# Response to Stakeholder Comments on Lake Santa Fe and Alto MFL Technical Documents

Suwannee River Water Management District

## 1.0 Response to Comments from Paul Still

Response to Comments provided by Paul Still, District 5 Board Member, Bradford Soil & Water Conservation District (Submitted by email on 12/20/2021)

The three graphs that follow illustrate this method using three different Minimum Frequent High Level

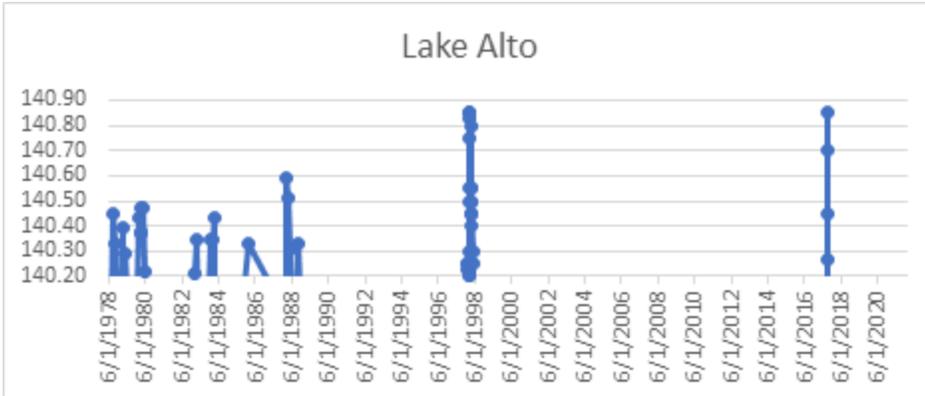
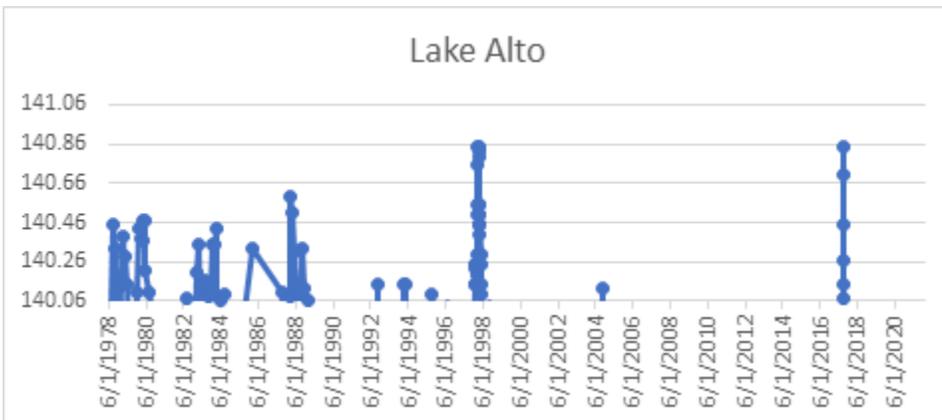
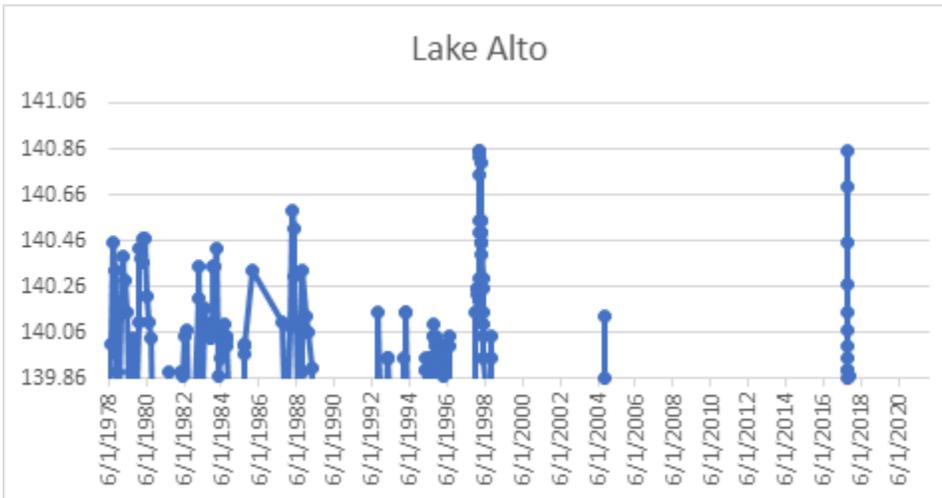
A spreadsheet program with graphing capabilities can demonstrate current compliance with the rule language. All that is required is the existing lake level data. The first step is to determine whether an even or odd year will be used as the start date for the analysis. The start date of June 1, set by rule, of the odd or even year is then made the first value in the spread sheet. A graph is then created with a yearly horizontal axis and lake level as the vertical axis. The lowest line on the vertical axis is set at the Minimum High Frequency Level set by rule. Only periods that meet the Minimum High Frequency Level will appear on the graph so it is relatively easy to identify any two-year periods that do not have 30 days above the minimum level.

Minimum High Frequency Level 140.20 recommended for Lake Alto

Minimum High Frequency Level of 140.06 recommended for Lake Santa Fe.

Minimum High Frequency Level of 139.86 suggested by BSWCD (see item 5 in this document)

The level data for Lake Alto for part of September 2017 shows the spike in the graph did not meet the 30-day duration requirement.

The above 3 graphs demonstrate that Lake Alto is not meeting a 30-day duration 2-year return interval for the Minimum High Frequency Level that was established in FAC 40B-8.121.

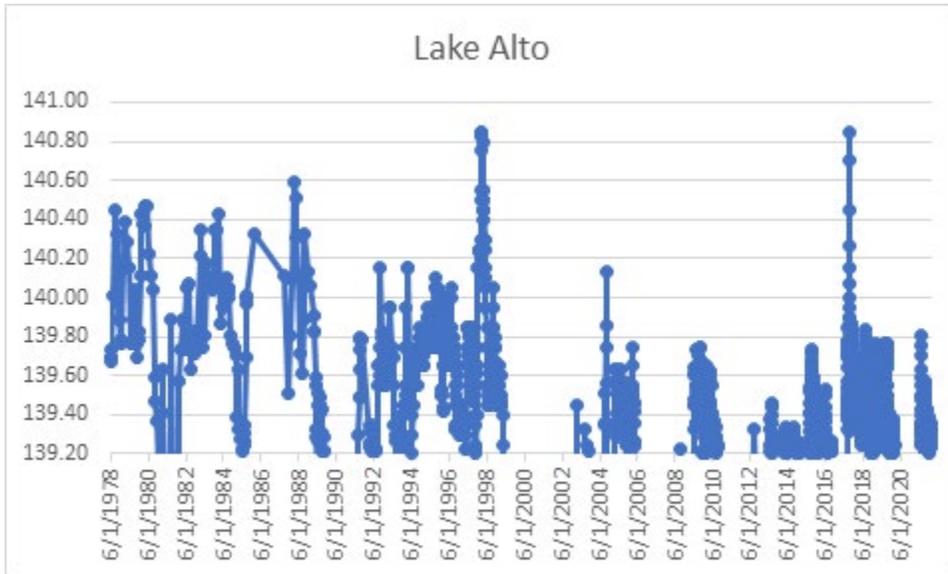
The Minimum Flows and Levels: Lake Altho Alachua County, Florida, April 30, 2014, recommended a Minimum High Frequency Level of 139.20. The graph that follows and the spreadsheet highlighted data show that the Minimum High Frequency Level of 139.20 was met for the time period June 1, 2018, to May 31, 2020, and has already been met for the time period June 1, 2020, to May 31, 2022.

A lowering of the Minimum High Frequency Level of only 0.66 feet moved Lake Alto from not currently meeting to meeting the Minimum High Frequency Level. The impact of this change may require a reconsideration of the simulated data instead of observed water level data if the model used is not calibrated better than the current model being used for the Lake Santa Fe and Lake Alto minimum levels.

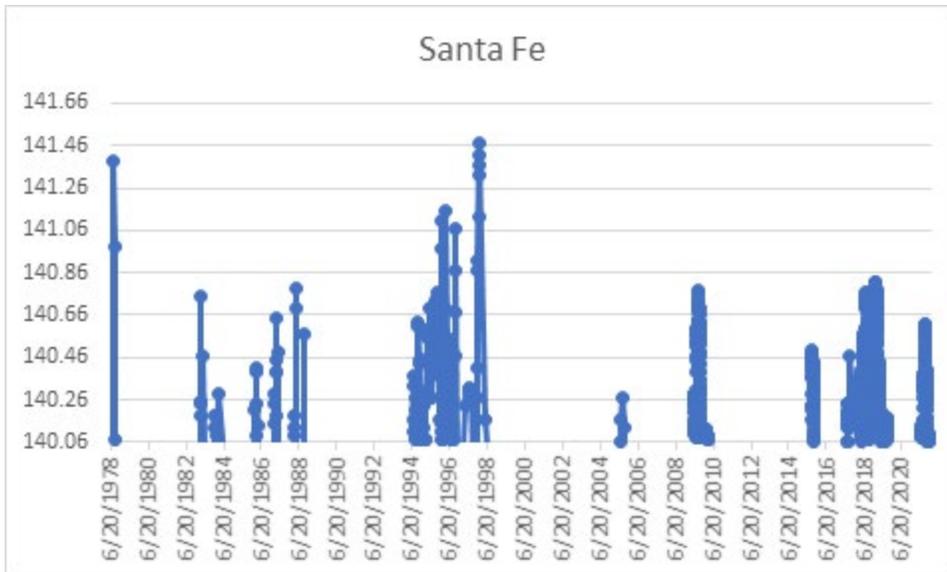
When Lake Santa Fe levels are evaluated using the graph and spreadsheet method the Minimum Frequent High level of 140.06 feet was met for the for the time period June 1, 2018, to May 31, 2020, and has already been met for the time period June 1, 2020, to May 31, 2022.

The graph also clearly demonstrates that there were periods when the Minimum Frequent High level of 140.06 feet would not have been met. This should raise some concern about the need to develop a prevention plan for Lake Santa Fe.

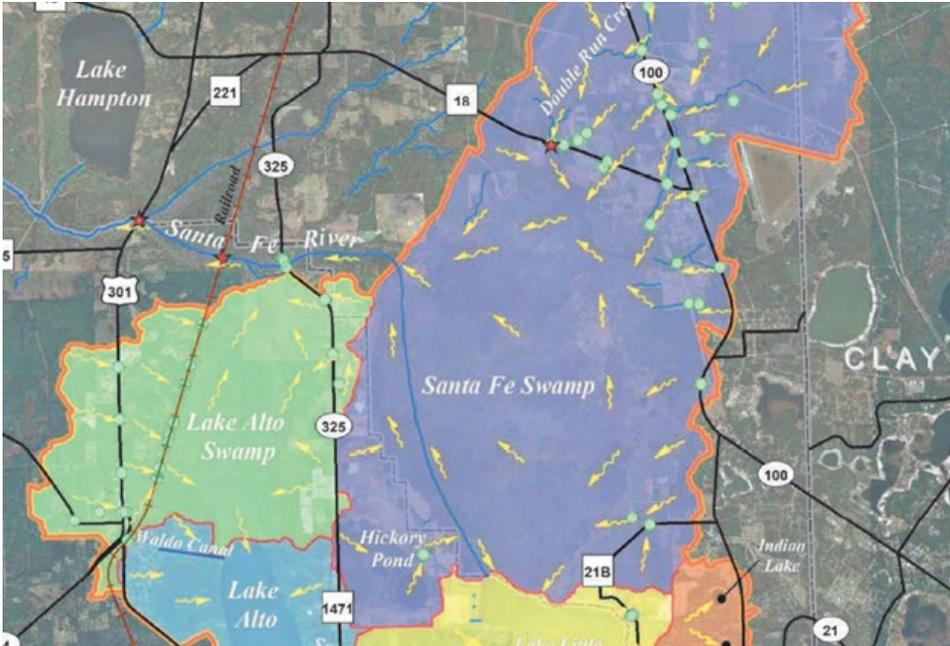
The Waldo Canal has its own drainage basin. During and after rain events the gauge could be recording Waldo Canal levels that are above actual levels in Lake Alto.

**Recommendation:** SRWMD should establish a lake level gauge directly in Lake Alto.

The District is planning to relocate the Lake Alto water level gage to a better location as part of the additional data collection for the lake.

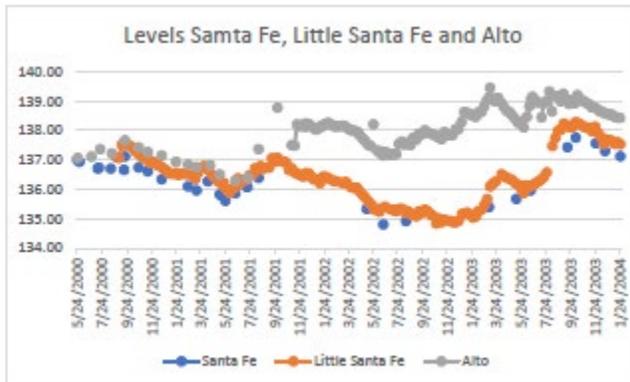
**Impact of Climate Change** There may be no way to predict rainfall and ET and these are two key elements in any water level model because of potential changes in storm intensities and prolonged drought periods. There can be significant investment in homes around lakes and these homes can be flooded during periods of high rainfall events. Balancing the risk of flooding and the potential impact of setting the minimum high lake level too high needs to be considered for those lakes where lake levels are controlled by outflow canals. The level of Lake Hampton is controlled by the condition of the canal that connects Lake Hampton to the Santa Fe River. When there are no factors that would significantly reduce flow through that canal Lake Hampton's peak levels would be expected to be lower than would occur if the canal has fallen trees, vegetation, or sediment that reduces flow through the canal. Human actions or inaction thus control the level of Lake Hampton. The levels of Lakes Sampson, Crosby, and Rowell are controlled by an operable control structure on the CR 225 Bridge. The operation plan for the CR 225 control structure has a significant impact on flooding of homes around Lakes Sampson and Crosby. Because a lakes minimum high level impacts the storage capacity of the lake, flooding of improved properties should be considered when the Minimum High lake levels are set.

MFLs are intended to support water supply planning activities and are required to use the best available information to estimate effects of current and future withdrawals on lake levels. To address potential future changes in rainfall, ET, and other factors that affect lake hydrology the District will re-evaluate the lake MFLs on a periodic basis as warranted.

Per state statute (373.042, F.S), MFLs are defined as the limit at which further withdrawals would be significantly harmful to the water resources or ecology of the area. Lake MFLs are therefore specifically focused on how withdrawals may lower lake levels and are not intended to address flooding concerns, which are the focus of the District's flood protection program.

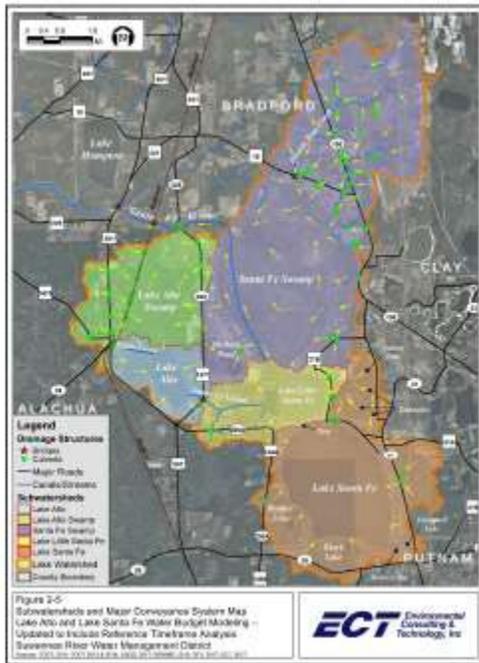
The impact of reduced flow caused by partial blockage may have been the cause of the significant differences between Lake Alto and Little Lake Santa Fe that can be seen in the lake level data between September 2001 and July 2003. Lake Alto levels were 1.66 to 3.46 feet higher than the Little Lake Santa Fe levels. This difference could be explained by a blockage in the Waldo Canal that would have elevated the water level at the Alto gauge at the west end of the Waldo Canal. This could have caused higher levels at the Alto gauge than at the lake itself. Another possible explanation could be that there was reduced flow through the Santa Fe Canal resulting in higher levels in Lake Alto.

It would be worth the effort to see if anyone using Lake Alto between 2001 and 2003 could recall higher levels in Lake Alto or have pictures that show Lake Alto water levels.

The model as calibrated meets the needs of the District to establish minimum levels for Lake Santa Fe. It is not necessary to incorporate additional information based on the intended use of the model.

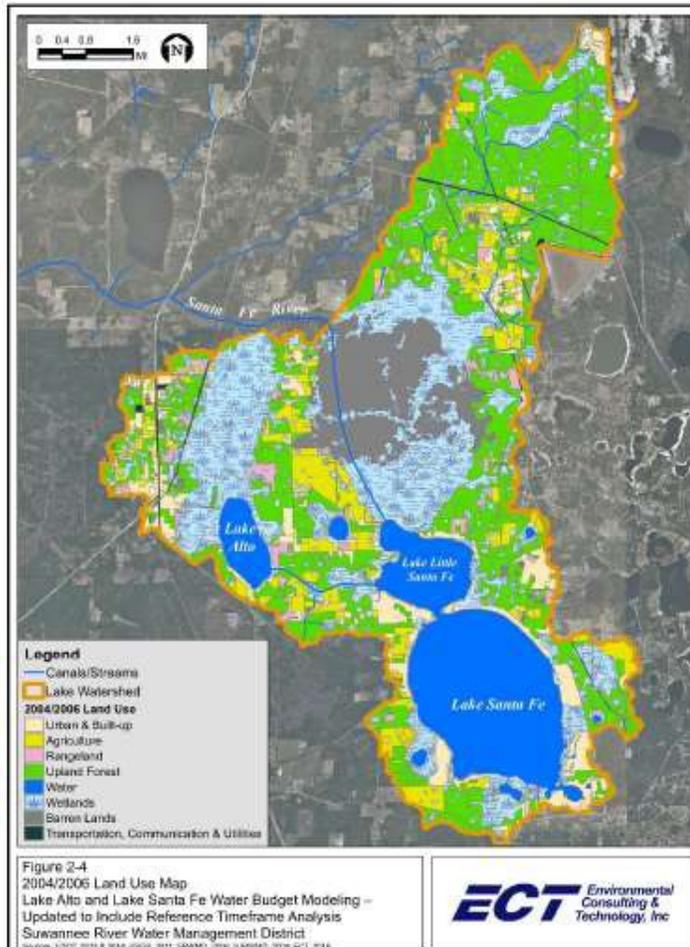
Santa Fe Lake, located in northeastern Alachua County, is largely sealed off from the principal aquifer, the Ocala limestone, by Pleistocene clayey sands and relatively impervious sediments of the Hawthorne formation. Sufficient rain water from the youthful plateau of pine-palmetto flatlands, swamps, and marshes slowly drains and seeps into the lake to largely offset losses from evaporation, transpiration, and seepage even during drought periods. In addition to discharge by

seepage in an eastward direction through surficial sands, overflow into a swampy area north of the lake occurs at times of unusually high water.

It is not known if the contents of the 1959 paper indicate that the Santa Fe River originates at Little Lake Santa Fe.

There appears to have been no attempt to verify that flow from Little Lake Santa Fe forms the headwaters for the Santa Fe River. Aerial imagery does not appear to support the location of a channel that would correspond to the dark blue line drawn through the Santa Fe Sump and labeled as the Santa Fe River in Figure 2.5.

See response to [Comment 8](#) from the Bradford Soil and Water Conservation District on 1/13/2022.

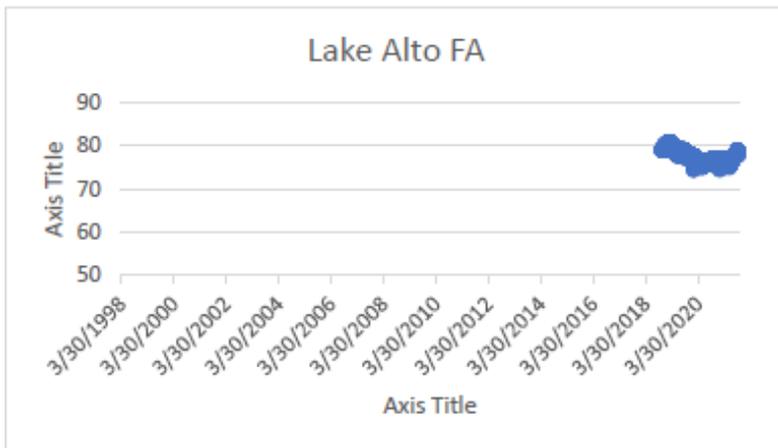
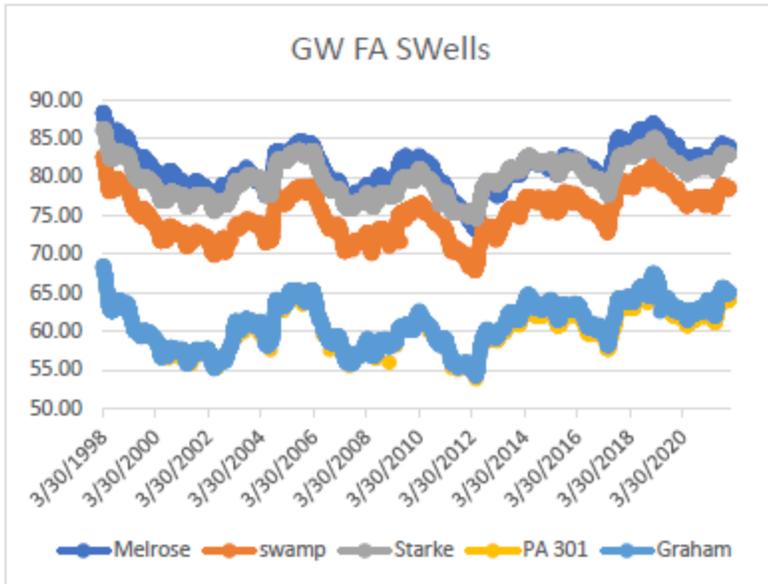
Flow to the Floridan Aquifer appears to be a significant part of the water budget however The Pirkle and Brooks 1959 Abstract quoted above indicates that Floridan aquifer levels may have limited impacts on Lake Santa Fe. Comparing the lake level changes in the lakes to the east of Lake Santa Fe seems to show two clear patterns. Some but not all of the lakes to the east show significant level variation attributed to seepage losses to the Floridan aquifer.

**A key question is: Can the loss of lake water to the Floridan Aquifer used in the ECT Model be supported by any data?**

The District developed a water budget model that was calibrated with lake level and groundwater level data to support development of MFLs for Lake Santa Fe.

The District is not aware of data regarding loss of lake water to the Floridan Aquifer for Lakes Alto and Santa Fe. Calibrated models are customarily used to estimate groundwater loss rates to underlying aquifers as described in Sections 3.3 and 4.3 of the 2021 Lake Santa Fe and Alto Modeling Report.
